NEEDS ASSESSMENT AND LEVEL OF SERVICE EVALUATION

APPENDIX D: AMERICANS WITH DISABILITIES ACT (ADA) FACILITY BARRIER REPORT

Americans with Disabilities Act (ADA) Facility Barrier Report

For Selected Park Sites

Red Sunset Park

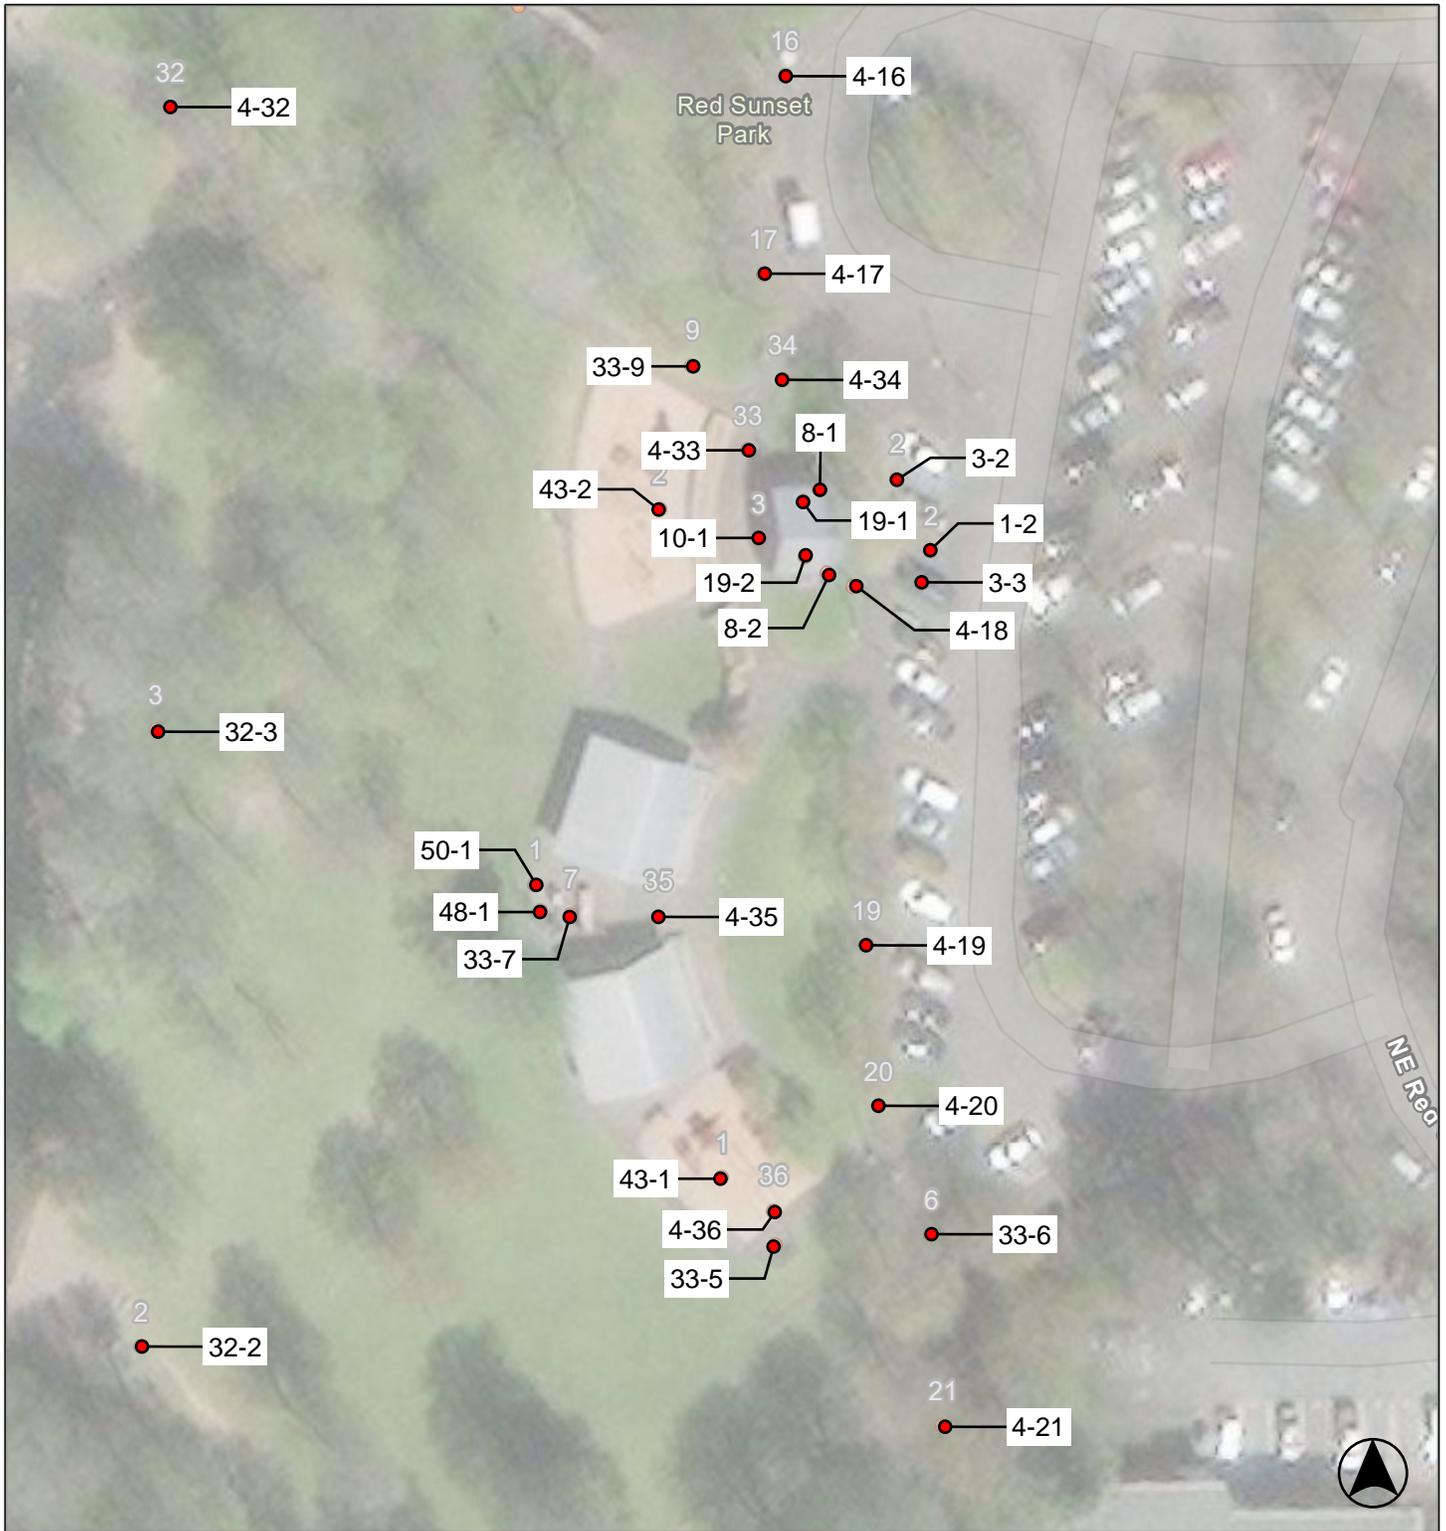
Park	
1 - 1	Parking Area Category: 1
Install van accessible sign	\$1,750
Notes: A "Van Accessible" sign is not provided ("Van Accessible" sign that is 18" wide by 9" high on a white retroreflective background and green retroreflective lettering provided at each van accessible space).	
ADA: 208.2.4, 502.6	
Other: OSSC 1106.7	
Regrade accessible parking space or access aisle	\$4,050
Notes: Slopes of accessible parking space and access aisle are up to 2.9% (2.0% max).	
ADA: 502.4	
Other: -	
Provide adequate striping	\$180
Notes: The words "No Parking" are not painted in the access aisle.	
ADA: -	
Other: OSSC 1106.7	
1 - 2	Parking Area Category: 1
Install van accessible sign	\$1,750
Notes: A "Van Accessible" sign is not provided ("Van Accessible" sign that is 18" wide by 9" high on a white retroreflective background and green retroreflective lettering provided at each van accessible space).	
ADA: 208.2.4, 502.6

Other: OSSC 1106.7	
Regrade accessible parking space or access aisle	\$4,050
Notes: Slopes of accessible parking space and access aisle are up to 3.4% (2.0% max).	
ADA: 502.4	
Other: -	
Provide adequate striping	\$180
Notes: The words "No Parking" are not painted in the access aisle.	
ADA: -	
Other: OSSC 1106.7	
Provide a pavement stencil	\$310
Notes: International symbol of accessibility pavement stencil is not provided. (28" high min, 24" wide min, painted with a 3" min stroke width of retroreflective white paint on an optional blue retroreflective background). ISA provided is faded and not retroreflective.	
ADA: -	
Other: OSSC 1106.7

Park	
3 - 1	Curb Ramp Category: 1
Grind or patch vertical change of grade	\$320
Notes: Curb ramp has a surface level change of 3/4" due to at transition (curb ramp must be free of level changes).	
ADA: 405.4	
Other: -	
Install, replace or modify curb ramp	\$17,150
Notes: Slope of the curb ramp is 8.8% (8.33% max).	
ADA: 405.2, 406.1	
Other: -	
Provide detectable warnings	\$1,270
Notes: Detectable warning surface does not contrast visually with adjacent walking surfaces (light-on-dark or dark-on-light).	
ADA: 705.1	
Other: -	
Reduce or eliminate opening	\$300
Notes: A horizontal gap across the ramp is greater than 1/2" wide (1/2" max).	
ADA: 302.3	
Other: -	
3 - 2	Curb Ramp Category: 1
Reduce or eliminate opening	\$300
Notes: A horizontal gap across the ramp is 1" wide (1/2" max).	
ADA: 302.3	
Other: -	
Provide detectable warnings	\$1,270
Notes: Detectable warning surface does not contrast visually with adjacent walking surfaces (light-on-dark or dark-on-light).

Park	
3 - 3	Curb Ramp Category: 1
Reduce or eliminate opening	\$300
Notes: A horizontal gap across the ramp is 1" wide (1/2" max).	
ADA: 302.3	
Other: -	
Provide detectable warnings	\$1,270
Notes: Detectable warning surface does not contrast visually with adjacent walking surfaces (light-on-dark or dark-on-light).	
ADA: 705.1	
Other: -	
4 - 1	Walk Category: 1
Regrade surface	\$4,700
Notes: Running slope of concrete is up to 7.1% for 47 linear feet (5.0% max).	
ADA: 403.3	
Other: -	
4 - 2	Walk Category: 1
Reduce or eliminate opening	\$300
Notes: Gap at cracks in concrete is greater than 1/2" (1/2" max).	
ADA: 302.3	
Other: -	
4 - 3	Walk Category: 1
Reduce or eliminate opening	\$300
Notes: Gap at cracks in concrete is greater than 1/2" (1/2" max).	
ADA: 302.3	
Other: -	
4 - 4	Walk Category: 1
Reduce or eliminate opening	\$300
Notes: Gap at cracks in concrete is greater than 1/2" (1/2" max).	
ADA: 302.3	
Other: -	
Regrade surface	\$6,300

Citizen Comment: There should be a curb ramp at this marked crosswalk.

Park	
4 - 26	Walk Category: 1
Regrade surface	\$8,100
Notes: Cross slope of concrete is up to 6.6% for 81 linear feet (2.0% max).	
ADA: 403.3	
Other: -	
Grind or patch vertical change of grade	\$100
Notes: Surface level change in path is greater than 1/4" (1/4" max; up to 1/2" with a 1:2 bevel)	
ADA: 303.2, 303.3	
Other: -	
4 - 27	Walk Category: 1
Reduce or eliminate opening	\$600
Notes: Gap at cracks in concrete is greater than 1" (1/2" max).	
ADA: 302.3	
Other: -	
Regrade surface	\$5,000
Notes: Cross slope of concrete is up to 4.7% for 50 linear feet (2.0% max).	
ADA: 403.3	
Other: -	
4 - 28	Walk Category: 1
Reduce or eliminate opening	\$600
Notes: Gap at cracks in concrete is greater than 1" (1/2" max).	
ADA: 302.3	
Other: -	
Grind or patch vertical change of grade	\$200
Notes: Surface level change is greater than 1/4" due to cracks (1/4" max; up to 1/2" with a 1:2 bevel).	
ADA: 303.2, 303.3	
Other: -	
4 - 29	Walk Category: 1

Park	
4 - 30	Walk Category: 1
Reduce or eliminate opening	\$600
Notes: Gap at cracks in concrete is greater than 1/2" (1/2" max).	
ADA: 302.3	
Other: -	
4 - 31	Walk Category: 1
Regrade surface	\$9,200
Notes: Running slope of path to bridge is up to 7.1% (5.0% max).	
On the bridge, the run slope was up to 6.5% and cross slope of 4.3% (2.0% max).	
Total segment length for 92 linear feet.	
ADA: 403.3	
Other: -	
Grind or patch vertical change of grade	\$100
Notes: Surface level change in path is greater than 1/4" (1/4" max; up to 1/2" with a 1:2 bevel)	
ADA: 303.2, 303.3	
Other: -	
4 - 32	Walk Category: 1
Regrade surface	\$13,200
Notes: Running slope of path from bridge is up to 10.5% (5.0% max). Cross slope on path of 4.3% (2.0% max).	
Total segment length is 132 linear feet.	
ADA: 403.3	
Other: -	
Grind or patch vertical change of grade	\$300
Notes: Surface level change in path is greater than 1/4" (1/4" max; up to 1/2" with a 1:2 bevel).

Surface level change on bridge is greater than 1" (1/4" max; up to 1/2" with a 1:2 bevel). (x2)	
ADA: 303.2, 303.3	
Other: -

Park	
4 - 33	Walk Category: 1
Regrade surface	\$3,500
Notes: Cross slope of in front of the dedication plaque is up to 3.0% for 10 linear feet (2.0% max).	
Cross slope around the playground is up to 3.8% for 25 linear feet (2.0% max).	
ADA: 403.3	
Other: -	
Grind or patch vertical change of grade	\$100
Notes: Tripping hazard in the walkway (1/4" max; up to 1/2" with a 1:2 bevel)	
ADA: 303.2, 303.3	
Other: -	
Reduce or eliminate opening	\$2,400
Notes: Gap at concrete joint is greater than 1/2" (1/2" max). (x8)	
ADA: 302.3	
Other: -	
4 - 34	Walk Category: 1
Regrade surface	\$1,000
Notes: Running slope of concrete is up to 5.5% for 10 linear feet (5.0% max).	
ADA: 403.3	
Other: -	
4 - 35	Walk Category: 1
Reduce or eliminate opening	\$1,200
Notes: Gap at concrete joints in front of the sink and shelter is greater than 1/2" (1/2" max). (x4)	
ADA: 302.3	
Other: -	
4 - 36	Walk Category: 1
Reduce or eliminate opening	\$300

Park	
8 - 1	Door/Gate Category: 1
Provide or modify door kick plate	\$350
Notes: A smooth and uninterrupted kick plate surface is not provided. A doorstop is located in the 10" space above the finish floor.	
ADA: 404.2.10	
Other: -	
Adjust door closer	\$160
Notes: Door closer sweep time is less than the five second minimum from 90 degrees to 12 degrees.	
Door opening force is 8 lbs (5 lbs max).	
ADA: 404.2.8.1, 404.2.9	
Other: OSSC 1102.1.2.5	
Enlarge door opening	\$4,650
Notes: Height of clear opening is 77" AFF (80" min). The mag lock protrudes into the head clearance.	
ADA: 404.2.3	
Other: -	
Reduce or eliminate opening	\$300
Notes: Gaps and cracks in the the landing/threshold create openings greater than 1/2" (1/2" max).	
ADA: 302.3	
Other: -	
Provide strike edge clearance	\$3,180
Notes: The push side clearance is obstructed by the lightswitch box and is less than 8" (8" min).	
ADA: 404.2.4.3	
Other: -

Park	
8 - 2	Door/Gate Category: 1
Provide or modify door kick plate	\$350
Notes: A smooth and uninterrupted kick plate surface is not provided. A doorstop is located in the 10" space above the finish floor.	
ADA: 404.2.10	
Other: -	
Adjust door closer	\$160
Notes: Door closer sweep time is less than the five second minimum from 90 degrees to 12 degrees.	
Door opening force is 12 lbs (5 lbs max).	
ADA: 404.2.8.1, 404.2.9	
Other: OSSC 1102.1.2.5	
Enlarge door opening	\$4,650
Notes: Height of clear opening is 78" AFF (80" min). The mag lock protrudes into the head clearance.	
ADA: 404.2.3	
Other: -	
Reduce or eliminate opening	\$300
Notes: Gaps and cracks in the the landing/threshold create openings of 5/8" (1/2" max).	
ADA: 302.3	
Other: -	
10 - 1	Drinking Fountain Category: 3
Confirm water flow compliance	\$0
Notes: Water service to the drinking fountain was disconnected at the time of the assessment. Flow height and angle could not be confirmed.

ADA: 602.3, 602.6	
Other: -	
10 - 2	Drinking Fountain Category: 3
Confirm water flow compliance	\$0
Notes: Water service to the drinking fountain was disconnected at the time of the assessment. Flow height and angle could not be confirmed.	
ADA: 602.3, 602.6	
Other: -	
Increase or provide maneuvering or clear floor area	\$1,270
Notes: The clear floor space has a greater than 1/2" gap in the pavement (1/2" max).	
ADA: 305.1, 305.2, 305.3, 305.5, 306.1	
Other: -

Park	
10 - 3	Drinking Fountain Category: 3
Confirm water flow compliance	\$0
Notes: Water service to the drinking fountain was disconnected at the time of the assessment. Flow height and angle could not be confirmed.	
ADA: 602.3, 602.6	
Other: -	
Increase or provide maneuvering or clear floor area	\$1,270
Notes: The clear floor space has a trench drain with 5" slots, creating openings (1/2" max).	
ADA: 305.1, 305.2, 305.3, 305.5, 306.1	
Other: -

Park	
19 - 1 Multiple User Restroom	Category: 2
Install restroom sign	\$250
Notes: A tactile and braille restroom sign is not provided. Women's restroom side.	
ADA: 216.2, 216.8	
Other: -	
Insulate water lines	\$160
Notes: The lavatory drain pipes are not insulated.	
ADA: 606.5	
Other: -	
Reposition clothing hooks	\$160
Notes: The coat hook in the accessible compartment is more than 48" AFF (48" max).	
ADA: 308.1	
Other: -	
Provide or replace compartment door hardware	\$550
Notes: Water closet compartment door is not self-closing.	
The door is not on the corner furthest from the water closet.	
ADA: 604.8.1.2	
Other: -	
Modify stall partitions	\$650
Notes: Clear width over water closet is 45" (60" min) to the wall.	
ADA: 604.3.1	
Other: -	
Reposition toilet flush controls	\$160
Notes: Flush control is not located on wide side of the water closet (flush control is required to be located on the open side of the fixture).

ADA: 604.6	
Other: -	
Replace or modify grab bars	\$480
Notes: A rear and vertical grab bar are not provided.	
The side grab bar is 41" long (42" min) and ends less than 54" from the rear wall (54" min).	
ADA: 604.5.1, 604.5.2	
Other: A117.1 604.5.1.2

Park	
19 - 1 Multiple User Restroom	Category: 2
Replace or reposition dispenser	\$160
Notes: The toilet paper is 7" above the side grab bar (12" min).	
ADA: 604.7	
Other: -	
Replace toilet or adjust toilet seat height	\$2,850
Notes: Water closet seat height is 19-1/2" AFF (17" min to 19" max).	
ADA: 604.4	
Other: -

Park	
19 - 2 Multiple User Restroom	Category: 2
Install restroom sign	\$250
Notes: A tactile and braille restroom sign is not provided. Men's restroom side.	
ADA: 216.2, 216.8	
Other: -	
Insulate water lines	\$160
Notes: The lavatory drain pipes are not insulated.	
ADA: 606.5	
Other: -	
Provide or replace compartment door hardware	\$550
Notes: Water closet compartment door does not interior or exterior handles.	
ADA: 604.8.1.2	
Other: -	
Modify stall partitions	\$650
Notes: Clear width over water closet is 47" (60" min) to the wall.	
ADA: 604.3.1	
Other: -	
Reposition toilet flush controls	\$160
Notes: Flush control is not located on wide side of the water closet (flush control is required to be located on the open side of the fixture).	
ADA: 604.6	
Other: -	
Replace or modify grab bars	\$480
Notes: A rear and vertical grab bar are not provided.	
The side grab bar extends to 53" from the rear wall (54" min).	
ADA: 604.5.1, 604.5.2

Other: A117.1 604.5.1.2	
Replace or reposition dispenser	\$160
Notes: The centerline of the toilet paper in front of the water closet is 13" (7" min and 9" max).	
ADA: 604.7	
Other: -	
Replace urinal	\$2,385
Notes: Height of the urinal rim is 19" AFF (17" max).	
ADA: 605.2	
Other: -

Park	
19 - 2 Multiple User Restroom	Category: 2
Replace or reposition fixtures	\$1,590
Notes: The centerline of the water closet is 18-1/2" from the wall (16" min to 18" max).	
ADA: 604.2	
Other: -	
Replace or adjust water controls	\$640
Notes: Water flows from the lavatory faucet for 4 seconds (10 seconds min).	
Operating effort of lavatory faucet is 8 lbs (5 lbs max).	
ADA: 309.1, 606.4	
Other: -	
29 - 1 Game and Sports Area	Category: 2
Provide wheelchair seating	\$3,600
Notes: No wheelchair spaces are provided near the approximately 50 spectator bleacher seats (2 wheelchair spaces min for 26 to 50 seats). (x2 sets of bleachers)	
ADA: 221.2.1.1	
Other: -	
Provide wheelchair seating	\$1,800
Notes: No wheelchair spaces provided in team seating areas (two min - one per team space).	
ADA: 221.2.1.4	
Other: -	
32 - 1 Picnic Area	Category: 2
Provide an accessible table	\$3,250
Notes: Knee clearance measured 8" horizontally from the front face of the table top is 25" (27" min).

ADA: -	
Other: ABA 306.3	
Increase or provide clear floor area	\$200
Notes: There is a 1" gap in the clear floor space of the picnic table (1/2" max).	
ADA: -	
Other: ABA 1011.2.1

Park	
32 - 2 Picnic Area	Category: 2
Provide an accessible route	\$6,400
Notes: An accessible route to the picnic table is not provided. Route is 80 linear feet over grass from the path to picnic area (36" wide min path of travel constructed with an accessible surface).	
ADA: -	
Other: ABA F206.2.2, ABA F245.4	
32 - 3 Picnic Area	Category: 2
Provide an accessible route	\$6,400
Notes: An accessible route to the picnic table is not provided. Route is 80 linear feet over grass from the path to picnic area (36" wide min path of travel constructed with an accessible surface).	
ADA: -	
Other: ABA F206.2.2, ABA F245.4	
Provide an accessible table	\$3,250
Notes: Knee clearance measured 8" horizontally from the front face of the table top is 26" (27" min).	
ADA: -	
Other: ABA 306.3	
32 - 4 Picnic Area	Category: 2
Provide an accessible route	\$1,600
Notes: An accessible route to the picnic table is not provided. Route is 20 linear feet over grass from the path to picnic area (36" wide min path of travel constructed with an accessible surface).

ADA: -	
Other: ABA F206.2.2, ABA F245.4	
Provide an accessible table	\$3,250
Notes: Knee clearance measured 8" horizontally from the front face of the table top is 26" (27" min).	
ADA: -	
Other: ABA 306.3	
Increase or provide clear floor area	\$200
Notes: The clear space around the grill narrows down to 24" (48" min wide).	
ADA: -	
Other: ABA 1011.2.1	
Regrade surface	\$20
Notes: Slope of the clear floor space around the grill is up to 3.9% (2.0% max).	
ADA: -	
Other: ABA 1011.2.3

Park	
32 - 5 Picnic Area	Category: 2
Provide an accessible table	\$3,250
Notes: Knee clearance measured 8" horizontally from the front face of the table top is 26" (27" min).	
ADA: -	
Other: ABA 306.3	
Increase or provide clear floor area	\$200
Notes: The clear space around the grill narrows down to 24" (48" min wide).	
ADA: -	
Other: ABA 1011.2.1	
33 - 1 Outdoor Constructed Features	Category: 3
Increase or provide clear floor area	\$200
Notes: A clear ground space is not provided adjacent to the bench (36" by 48" min).	
ADA: -	
Other: ABA 1011.2.1, ABA 1011.2.3	
33 - 2 Outdoor Constructed Features	Category: 3
Increase or provide clear floor area	\$200
Notes: A clear ground space is not provided adjacent to the bench (36" by 48" min).	
ADA: -	
Other: ABA 1011.2.1, ABA 1011.2.3	
33 - 3 Outdoor Constructed Features	Category: 3
Increase or provide clear floor area	\$200
Notes: There is a greater than 1/2" gap in the pavement in front of the trash container (1/2" max).

ADA: -	
Other: ABA 1011.2	
33 - 4 Outdoor Constructed Features	Category: 3
Increase or provide clear floor area	\$200
Notes: There is a greater than 1" gap between the bench and the trash container (1/2" max).	
ADA: -	
Other: ABA 1011.2	
33 - 5 Outdoor Constructed Features	Category: 3
Increase or provide clear floor area	\$200
Notes: A clear ground space is not provided adjacent to the bench (36" by 48" min). Space is too narrow.	
ADA: -	
Other: ABA 1011.2.1, ABA 1011.2.3

Park	
33 - 6	Outdoor Constructed Features Category: 3
Increase or provide clear floor area	\$200
Notes: Clear ground space adjacent to the bench has a slope of 3.7% (2.0% max).	
ADA: -	
Other: ABA 1011.2.1, ABA 1011.2.3	
33 - 7	Outdoor Constructed Features Category: 3
Replace or reposition picnic grill	\$950
Notes: Cooking surface is 40" above the ground (34" max).	
ADA: -	
Other: ABA 1011.5.2	
33 - 8	Outdoor Constructed Features Category: 3
Increase or provide clear floor area	\$200
Notes: Clear ground space adjacent to the trash can has a slope of 3.7% (2.0% max).	
ADA: -	
Other: ABA 1011.2.1, ABA 1011.2.3	
33 - 9	Outdoor Constructed Features Category: 3
Increase or provide clear floor area	\$200
Notes: A clear ground space is not provided adjacent to the bench (36" by 48" min).	
ADA: -	
Other: ABA 1011.2.1, ABA 1011.2.3	
35 - 1	Other Category: 3
Reposition controls	\$285
Notes: Operating mechanism of dog bag station is 52" above the ground (15" min to 48" max). Dispenser is out of reach range.

ADA: 308.2, 308.2.1	
Other: -	
35 - 2	Other Category: 3
Reposition controls	\$285
Notes: The horizontal reach range is 60" over grass (24" max horizontal reach).	
ADA: 308.2.2	
Other: -	
35 - 3	Other Category: 3
Increase or provide maneuvering or clear floor area	\$200
Notes: Clear floor space of the dog bag stations is not provided (30" by 48" min).	
ADA: 305.2, 305.3, 305.5	
Other: -

Park		
35 - 4	Other	Category: 3
Reposition controls		\$285
Notes: Operating mechanism of the dog bag station is 56" above the ground (15" min to 48" max).		
The reach is 32" horizontally and out of reach range (24" max).		
ADA: 308.2, 308.2.1		
Other: -		
43 - 1	Play Equipment Area	Category: 2
Improve or evaluate play area surface		\$0
Notes: Ground surface in play area is in need of maintenance and further evaluation of fall attenuation surface is recommended.		
ADA: 1008.2.6.1, 1008.2.6.2		
Other: -		
Regrade or replace ramp		\$540
Notes: The ramp runs connecting ground level play components within the play structure have a slope of 9.1% (6.25% max).		
ADA: 1008.2.5.1		
Other: -		
43 - 2	Play Equipment Area	Category: 2
Improve or evaluate play area surface		\$0
Notes: Ground surface in play area is in need of maintenance and further evaluation of fall attenuation surface is recommended.		
ADA: 1008.2.6.1, 1008.2.6.2

Other: -		
Install or modify transfer system		\$6,350
Notes: The transfer step is 8-1/2" high (8" max).		
ADA: 1008.3.2.1, 1008.3.2.2		
Other: -
